Access Compliance Report

Public Rights-of-Way

Intersection ID: 27907	Main Street: BAY_HILL_CLUB_DR	Cross Street: COLONIAL_COUNTRY_LN	Location: NE
ADA ID: 1E3F0ACFF396	Ramp Type: Perp	Initial Pass/Fail: Pass	Overall Compliance: No
			Severity Score: 10

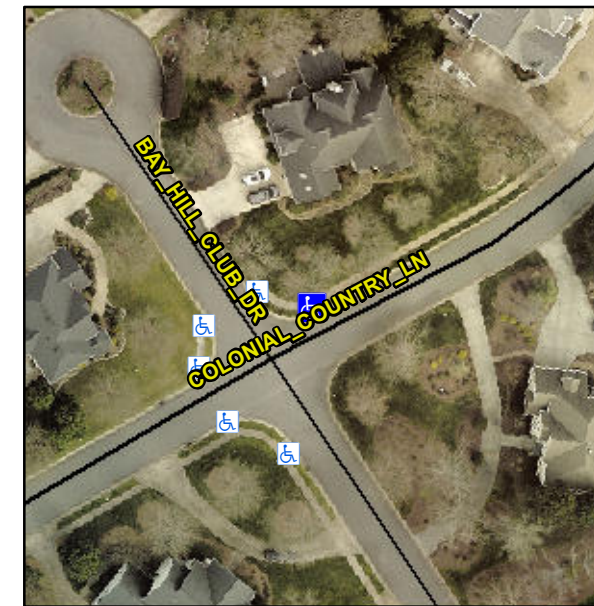
**Not Found, R304.2.1, R304.2.2-Perp,
R304.3.2-Para, R305, R304.5.3**

**Remove & Replace Entire Ramp.
Remove & Replace Gutter.**
